**From:** Fred Marinelli <[REDACTED]>  
**Sent:** Wednesday, July 18, 2012 10:20 AM  
**To:** Peter J. Hinck  
**Cc:** Cory D. Anderson; Tina Pint; Al Trippel; Carlson, Erik (DNR); David Blaha; Houston Kempton; Paul Haby; John L. Adams; Jim Scott ([REDACTED])  
**Subject:** Re: Cat 1 stockpile pH

Site: Mine Site

Activity: GoldSim Task 2 QA

Issue: Cat 1 stockpile

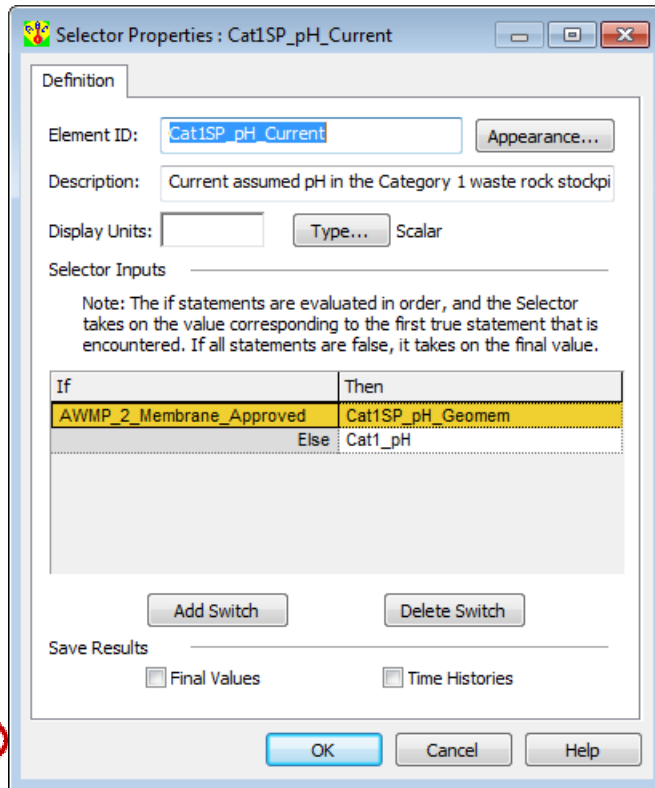
pH during closure with geomembrane installed

Model appears to be using a P50 pH = 7.25, which is appropriate for a soil cover.

Input tables indicate that the model should use P50 pH = 7.95 for a geomembrane cover.

We believe the programming issue is in Element ID: Cat1SP\_pH\_Current.

Cat 1 pH affects numerous geochemical calculations involving the concentration of constituents in Cat 1 seepage.

You are correct that the model files submitted 2 weeks ago did not have the pH of the Category 1 Waste Rock Stockpile modeled correctly. This was the result of some testing that I was doing, and I neglected to change the value back before submitting the models. See the screen shot below for the correct (and current) modeling of the referenced element (Cat1SP\_pH\_Current), with the line that needs to change circled (I believe the version you have just lists this as "false").

Erik et al., this error was corrected prior to performing the modeling runs used in the AWMP Version 2, submitted last week. The full package of model results posted to the project website, however, were from a modeling run that included this error. The effect of this change on the ultimate concentrations in the Partridge River and groundwater is minimal, but it does represent an inconsistency in the model. Please advise if you'd like us to update the posted results spreadsheets.
